**APPROVED MINUTES OF THE REGULAR SESSION OF THE
BUILDING BOARD OF APPEALS
CITY OF ANN ARBOR
APRIL 11, 2007 CITY – SECOND FLOOR - COUNCIL CHAMBERS
100 N. FIFTH AVENUE, ANN ARBOR, MI 48104**

2. **2007-B- 007 – 149 Hill Street**

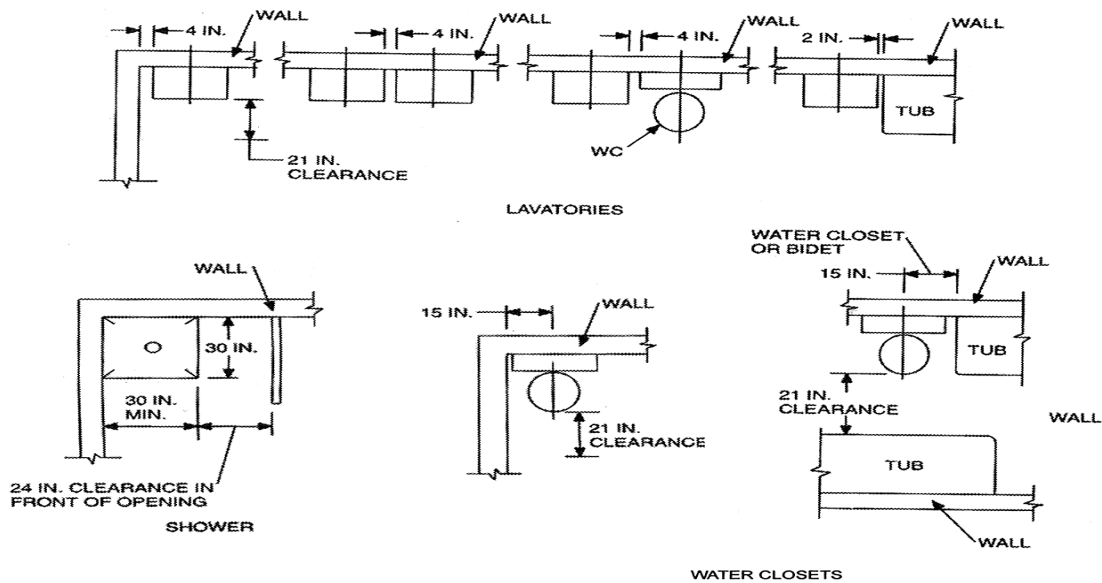
The applicant is requesting a variance from Section R307.1 of the 2003 Michigan Residential Code that requires that toilet fixtures spaced per the following diagram.

This property is rental housing. During the most recent housing inspection, it was found that the second floor bathroom does not meet code with relation to fixture clearances. There is not the required 24-inch clearance in front of the shower or the required 21-inch clearance in front of the lavatory. There is no permit on file for this work, and consequentially no inspection or final approval.

A. Savoni - Staff is not supportive of this request. This layout provides a trip hazard for anyone using the bathroom and must be corrected to meet code.

Discussion between the Board and the Petitioner regarding the actual measurements submitted on the drawings and that those dimensions are incorrect and not to scale.

89 *Discussion between the Board and Petitioner regarding possible solutions – A. Savoni also*
90 *stated that the petitioner will have to submit an accurate drawing and file for a permit.*

96 Moved by S. Callan, Seconded by R. Reik, “**to table the case of Appeal Number**
97 **2007-B-007, 149 Hill Street until the Petitioner can return with updated, scaled**
98 **revised drawings.”**
